Vermont Agency of Transportation
RECEIVED
Richford Precast Frame Complete Updated Submittal_Approved 7.23.15.pdf
CK'D BY CLB OK'D BY HIS
July 22, 2015
RESUBMIT NO Approved
BY C. CARLSON DATE 07/23/15

STATE AGENCY
VTrans

G.W. TATRO CONSTRUCTION, INC.
VT/AOT BRIDGE REPLACEMENT– ROAD IMPROVEMENT
RICHFORD, VT.

C | SHOP DRAWING C1 | REV 6
Drawing No. C22312-C1
Quantity: 1 | Project No: BRF030229 | SHEET 1 OF 14

PLAN VIEW
HEADWALL REINFORCING DETAIL
Scale: 1/4" = 1'-0"

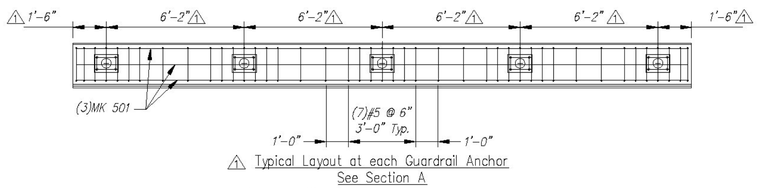
⚠1 Typical Layout at each Guardrail Anchor
See Section A

BENDING SCHEDULE
Scale: N.T.S.

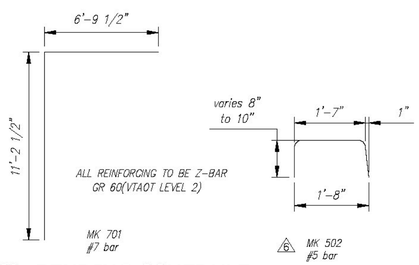
1 SHORTENED DI & ADDED REBAR TO HW TO EASE MFG
2 ALL DBS/DI WERE Z-BAR, NOW EPOXY COATED
3 REVISED PER CUSTOMER REVIEW
4 ADJUSTED WATER REPELLENT
5 10" WAS 9 1/2", HDWALL BEND SCHED – 8" WAS 7 1/2"
6 REVISED PER CUSTOMER REVIEW, REVISED GUARDRAIL ANCHOR SPACING, MOVED WINGWALL ANCHOR, ADDED NOTE
